APPLICATION NO.	FILING DATE	FIRST NAMED INVENTOR	ATTORNEY DOCKET NO.	CONFIRMATION NO.
10/825,407	04/14/2004	Keiji Ito	10873.1428US01	9378
23552	7590	04/07/2006	EXAMINER	
MERCHANT & GOULD PC P.O. BOX 2903 MINNEAPOLIS, MN 55402-0903			GOLUB, MARCIA A	
			ART UNIT	PAPER NUMBER
			2828

Office Action Summary	Application No.	Applicant(s)	
	10/825,407	ITO ET AL.	
	Examiner	Art Unit	
	Marcia A. Golub	2828

DETAILED ACTION

Regarding **claim 1**, Fig 1 of '222 discloses a semiconductor laser device, comprising:

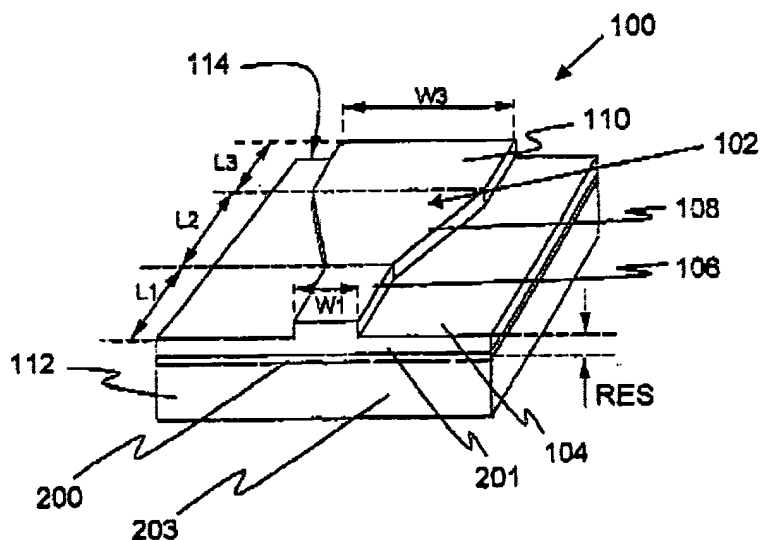
“a first conductivity type cladding layer [203]; an active layer [200]; and a second conductivity type cladding layer [201], which are on a substrate [204],

wherein the semiconductor laser device further comprises a stripe structure [102] for injecting carriers therein,

a width of the stripe is wider at a front end face [W3] of a resonator [100] from which laser light is emitted than at a rear end face [W1] that is located on an opposite side of the front end face, (paragraph 0062)

and a reflectance of the front end face [114] is lower than a reflectance of the rear end face [112].” (paragraph 0062)

Regarding **claims 3, 5, 6, 9-11**, Fig 1 of '222 discloses a semiconductor laser device, comprising:

3. “wherein at least the active layer [200:200b, 200b’] comprises an AlGaAs based semiconductor material (paragraph 0057);
5. “wherein a ratio between the stripe width [W3] at the front end face and the stripe width at the rear end face [W1] satisfies a relationship of $1 < (\text{the stripe width at the front end face}) / (\text{the stripe width at the rear end face}) < 2$ (for example: $W3=9$, $W1=5 \text{ um}$, $W3/W1=1.8$, paragraph 0023);

6. “wherein the ratio between the stripe width at the front end face and the stripe width at the rear end face satisfies a relationship of $1.4 < (\text{the stripe width at the front end face}) / (\text{the stripe width at the rear end face}) < 1.8$ (paragraph 0023);

9. “wherein the stripe structure has regions adjacent to the front end face [W3,L3] and the rear end face [W1,L1], the regions respectively extending inwardly from the front end face [114] and the rear end face [112] and each having a constant stripe width (paragraph 0062)

10. "wherein the regions having the constant stripe widths extend inwardly from the front end face and the rear end face, respectively, by a length of one-twentieth or shorter of a length of the resonator ($L1, L3 < L/20$); [$L3 > L/25$, $L1 < 16L/20$] (paragraphs 0024, 0026)

11. "wherein the reflectance of the front end face [85%] is lower than the reflectance of the rear end face [9%] by 15% or more." (paragraph 0062)
